PROPOSED TECHNICAL SPECIFICATION (TS) CHANGE

SEQUOYAH NUCLEAR PLANT UNITS 1 AND 2

DEPARTURE FROM NUCLEATE BOILING RATIO (DNBR) LIMITS BASES CHANGE

- 1) NUCLEAR PLANT(S): Sequoyah Units 1 and 2
- 2) SUBJECT (TITLE): Increased F Delta H from 1.55 to 1.62, Increased FQ From 2.32 to 2.4, With Mini RTDP
- 3) The written safety evaluation of the revised procedure, design change or modification required by 10CFR50.59(b) has been prepared to the extent required and is attached. If a safety evaluation is not required or is incomplete for any reason, explain on Page 2.

SEQUOYAH
 FINAL SAFETY ANALYSIS REPORT
 UNITS 1 and 2
 Startup of an Inactive Reactor Coolant Pump
 Active Loop Flow vs. Time;
 Core Flow vs. Time
 Figure 15.2.6-1

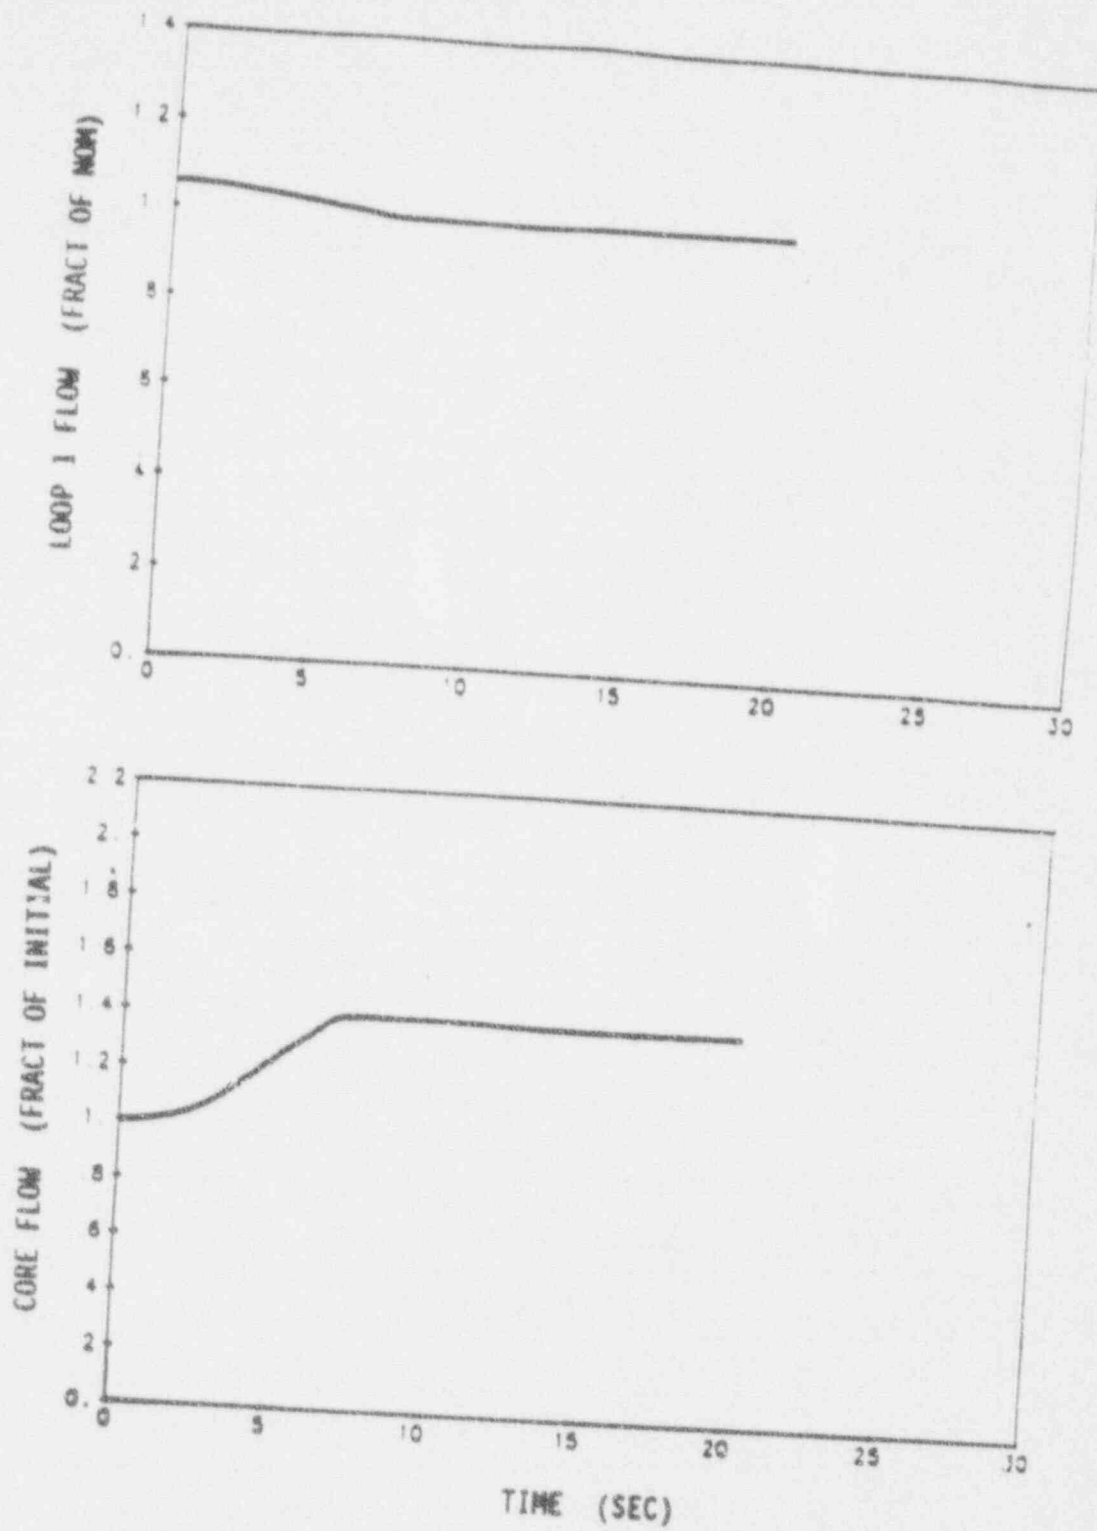
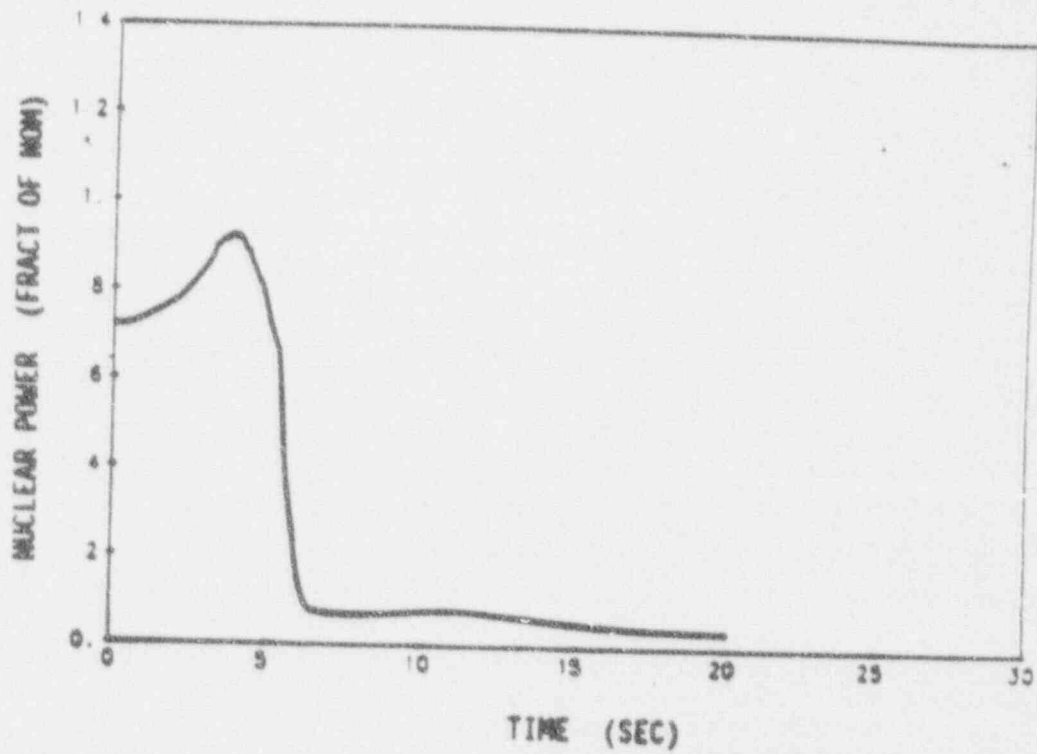
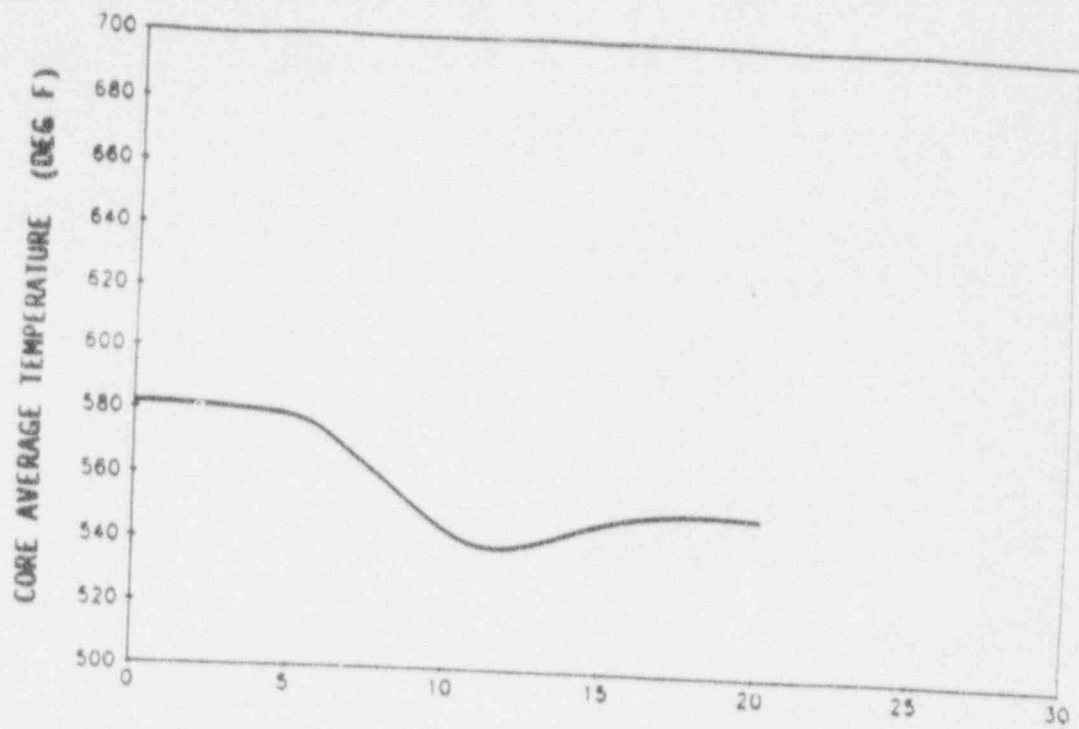
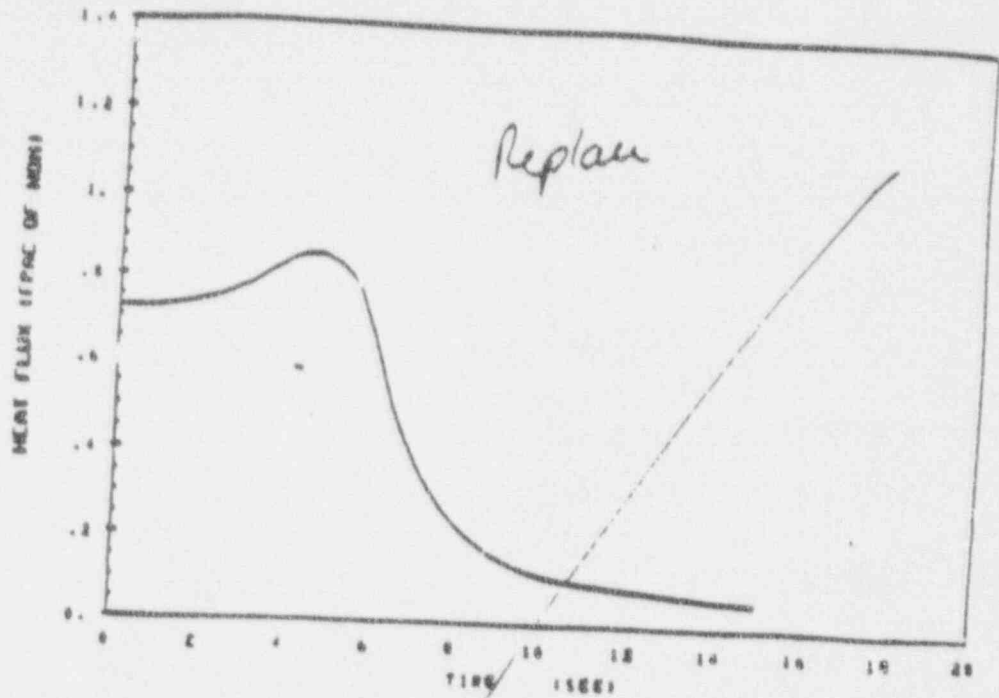
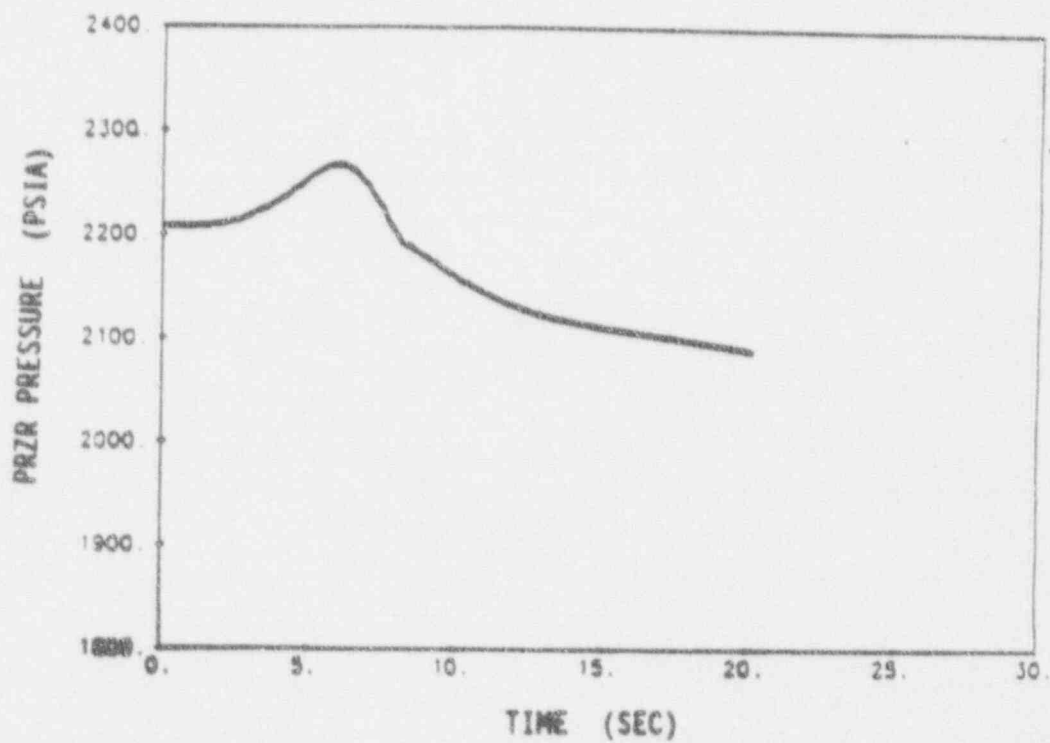
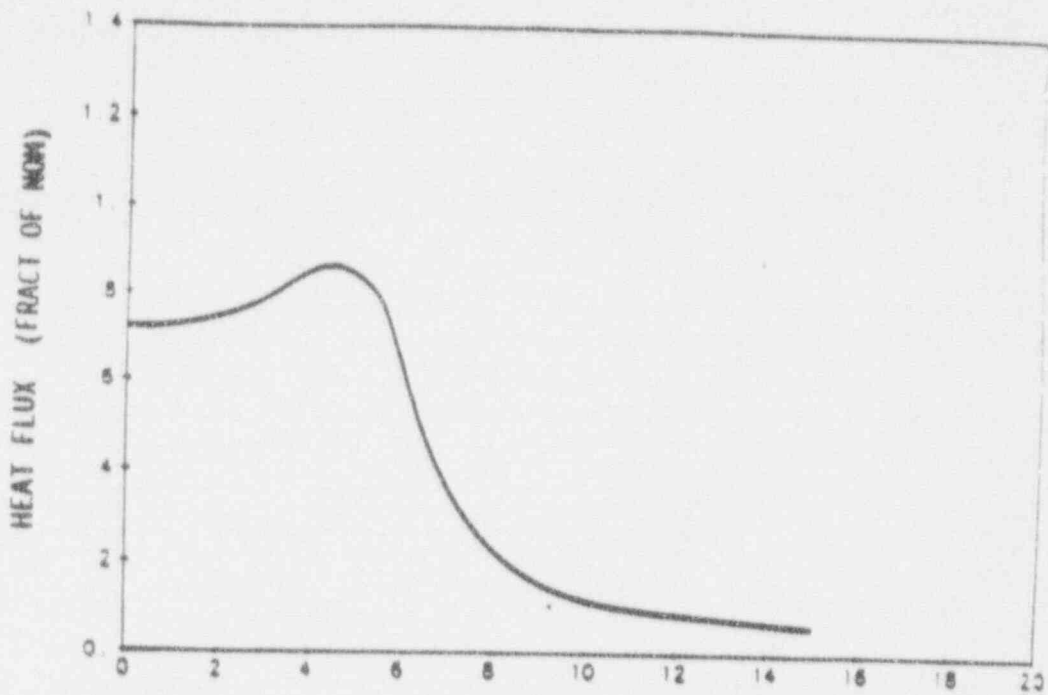
- 9.1.1 List of Figures
- 9.1.2 For the Startup of an Inactive Reactor Coolant Pump the following changes were made: Reference 3 updated, Table 15.2-1 (sheet 3), and Figures 15.2.6-1 through 15.2.6-4 were replaced.

The calculated sequence of events for this accident is shown on Table 15.2-1. The transient results illustrated in Figures 15.2.6-1 through 15.2.6-4 indicate that a stabilized plant condition, with the reactor tripped, is approached rapidly. Plant cooldown may subsequently be achieved by following normal shutdown procedures.

<p>SEQUOYAH FINAL SAFETY ANALYSIS REPORT UNITS 1 and 2</p>
<p>Complete Loss of Forced Reactor Coolant Flow Reactor Vessel Flow vs. Time</p>
<p>Figure 15.3.4-1</p>

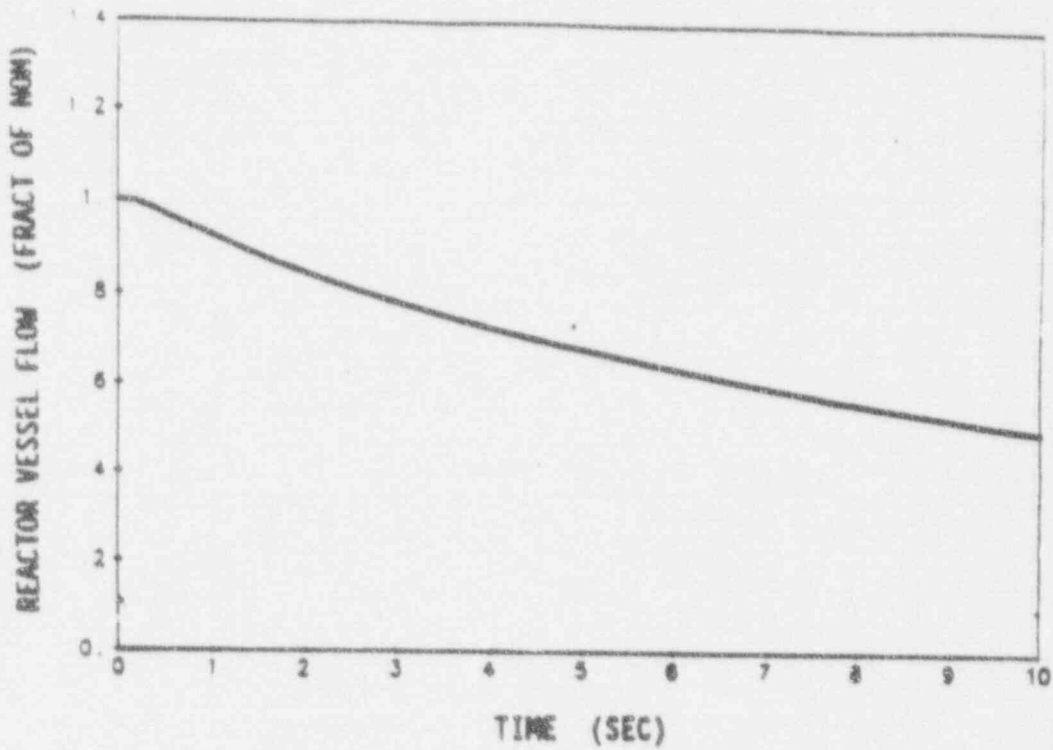
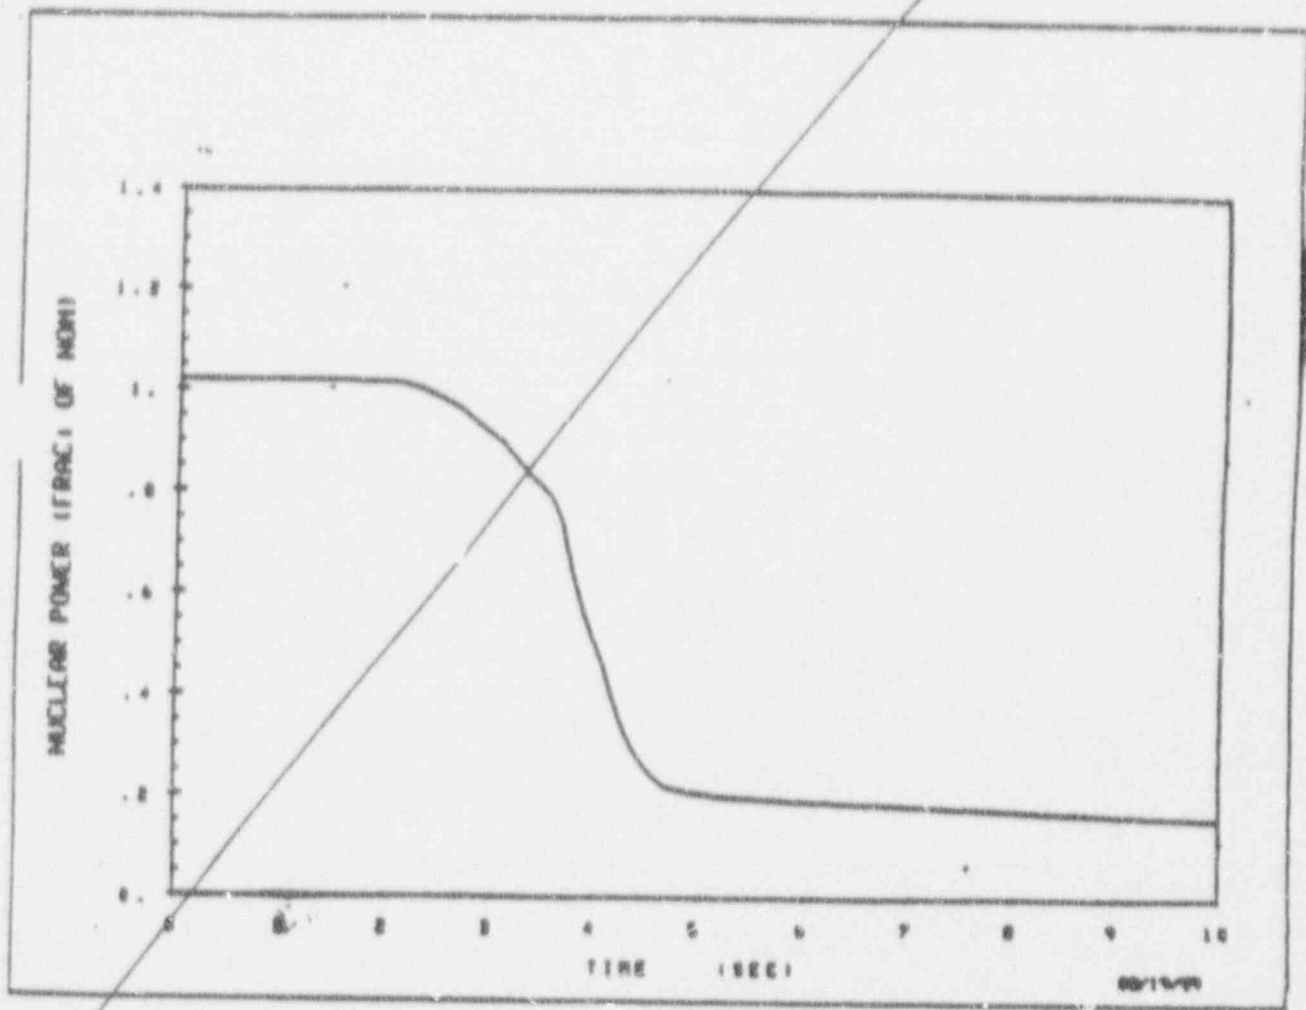
- 9.1.3 For the Complete Loss of Flow event the following changes were made: Text markups, Reference 8 updated, Table 15.3.4-1 revised, and Figures 15.3.4-1 through 15.3.4-3 were replaced.

The calculated sequence of events is shown in Table 15.3.4-1 for the limiting case analyzed. This case corresponds to a reactor trip occurring on a bus underfrequency condition. Figures 15.3.4-1 through 15.3.4-3 show the resulting transient conditions for the Complete Loss of Flow analysis. Included in these figures are total RCS flow, average and hot channel heat flux, nuclear power, and DNBR, each as a function of time. The minimum DNBR is not less than the safety analysis limit.

REPLACE WITH THE FOLLOWING

SEQUOYAH FINAL SAFETY ANALYSIS REPORT UNITS 1 and 2
Partial Loss of Forced Reactor Coolant Flow Reactor Vessel and Loop Flow vs. Time
Figure 15.2.5-1

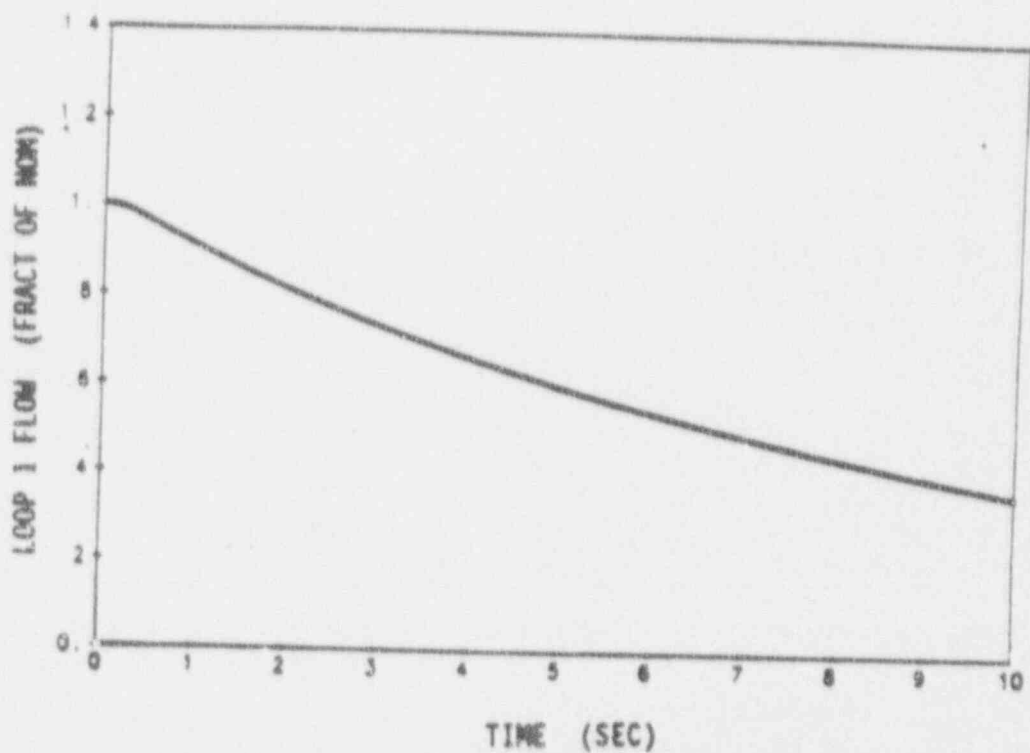
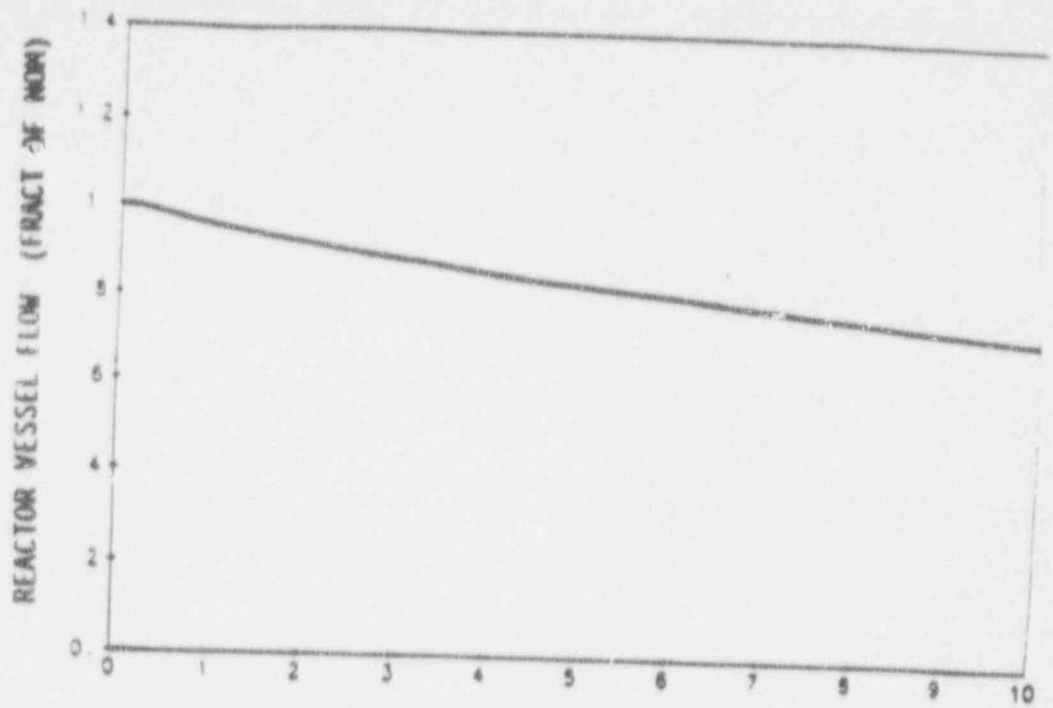
- 9.1.4 For the Partial Loss of Flow event the following changes were made: Text changes, Reference 3 update, Table 15.2-1 (sheet 2) revised, and Figures 15.2.5-1 through 15.2.5-3 were replaced.

Figures 15.2.5-1 through 15.2.5-3 show the resulting transient conditions for the 2/4 Partial Loss of Flow analysis. Included in these figures are total RCS flow, faulted loop flow, average and hot channel heat flux, nuclear power, and DNBR, each as a function of time.

REPLACE WITH THE FOLLOWING
